Ref.: TD 264 (PLEN) (Annex Q5-10)

Source: ITU-T Study Group 13 (Geneva, 16-27 April 2007)

Title: Issue on ETH-LB

LIAISON STATEMENT

Figure 1: Example configuration.

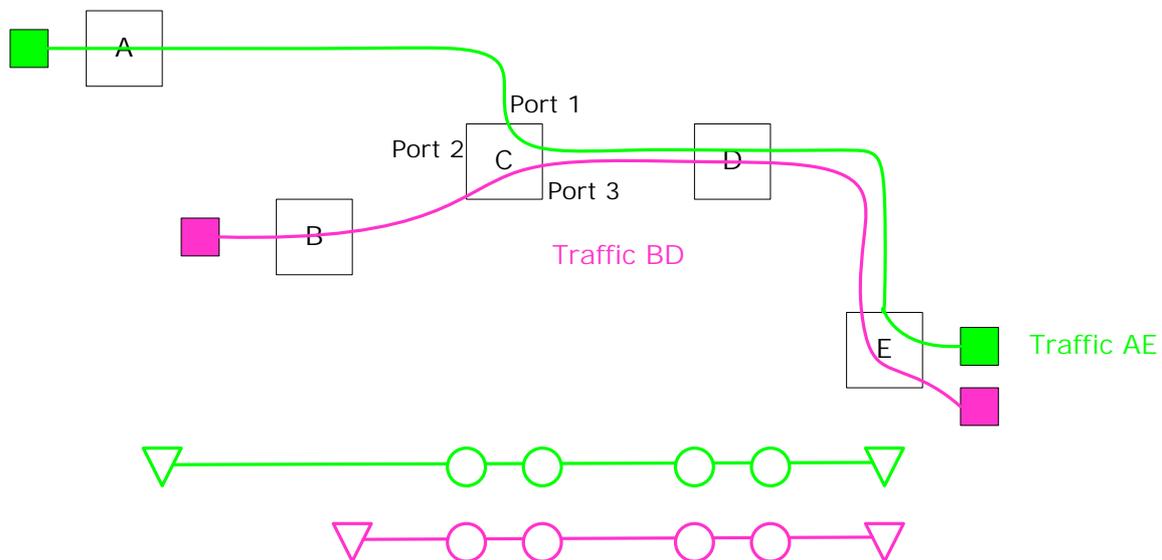
During the SG 13 meeting held in April 2007 the experts of Q.5/13 have found that ETH-LB cannot diagnose a mis-connection failure in case multiple MIPs share the same MAC address of the port on which the MIPs exist. Figure 1 shows an example:

Figure 2: Mis-connection example.

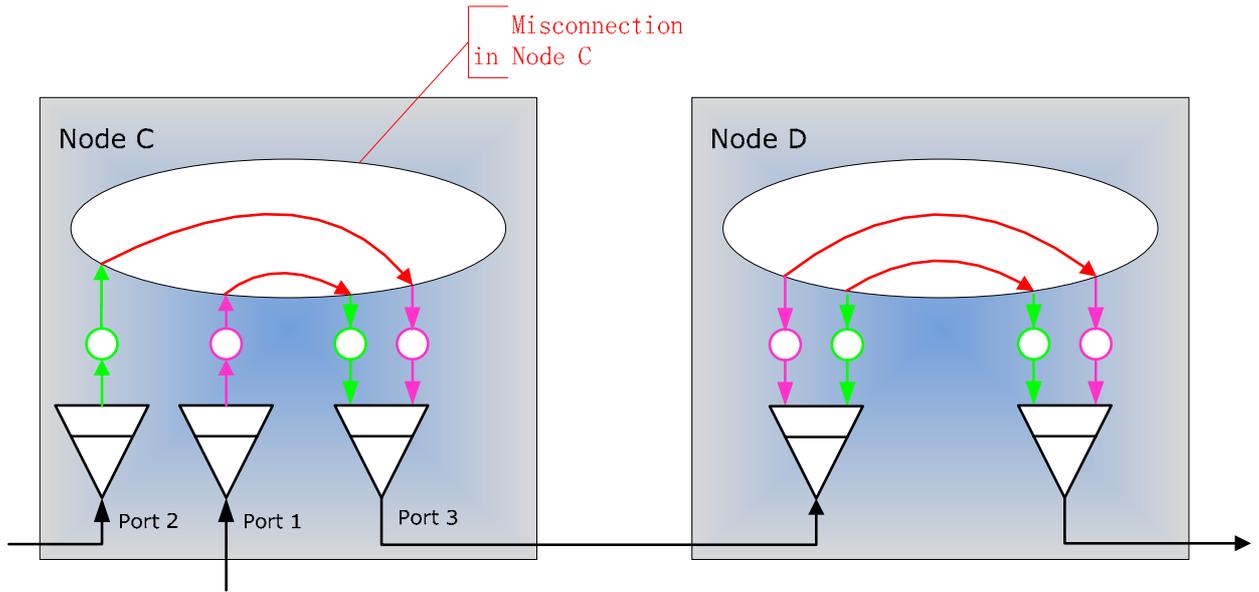
Figure 2 shows the mis-connection in node C which cannot be detected at node D.
